UNITED STATES PATENT AND TRADEMARK OFFICE

APPLICATION NO.	FILING DATE	FIRST NAMED INVENTOR	ATTORNEY DOCKET NO.	CONFIRMATION NO.
10/591,194	08/30/2006	Steven T. Peake	GB04 0052 US1	5898
65913	7550	10/02/2008		
NXP, B.V. NXP INTELLECTUAL PROPERTY DEPARTMENT M/S41-SJ 1109 MCKAY DRIVE SAN JOSE, CA 95131				
EXAMINER				
LEE, HSIEN MING				
ART UNIT		PAPER NUMBER		
2823				
NOTIFICATION DATE		DELIVERY MODE		
10/02/2008		ELECTRONIC

Office Action Summary

DETAILED ACTION

Fig. 1

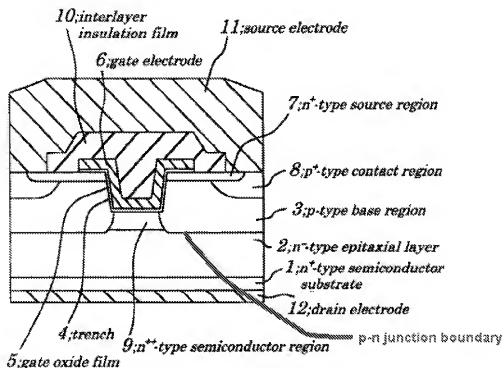
In re claim 1, Yamada, in Figs. 1-11 and corresponding text, A method of manufacturing an insulated gate field effect transistor; includes:

- providing a substrate 1 having a first major surface having a low-doped region 2 at the first major surface, the low-doped region 2 having a concentration of less than $5 \times 10^{14} \text{ cm}^{-3}$ (i.e. from 10^{13} to 10^{14} , col. 9, lines 20-21) at the first major surface;

- forming gate trenches 4 extending from the first major surface;
- forming trench insulator 5 on the base and sidewalls of the gate trenches 4;
- implanting dopants of a first conductivity type (i.e. n type) at the base of the trenches 4 (Fig.4);

- implanting a body implant of second conductivity type (i.e. p type) opposite to the first conductivity type (i.e. n type) in the low-doped regions between the trenches 4 to form a region 3;

- carrying out a diffusion step to form an insulated gate transistor structure in which the body implant diffuses towards the substrate 1 in the low-doped region 2 to form a p-n junction between a body region 3 doped to have the second conductivity type (i.e. p type) above a drain region (col. 8, line 51) doped to have the first conductivity type (i.e. n type), the p-n junction being deeper below the first major surface between the trenches than at the trenches; and

- forming source regions 7 at the first major surface adjacent to the trench 4.

In re claim 2, Yamada teaches that the p-n junction boundary between drain region and body region 3 is deeper between the gate trenches 4 than the depth of the gate trenches 4 (Fig.1).
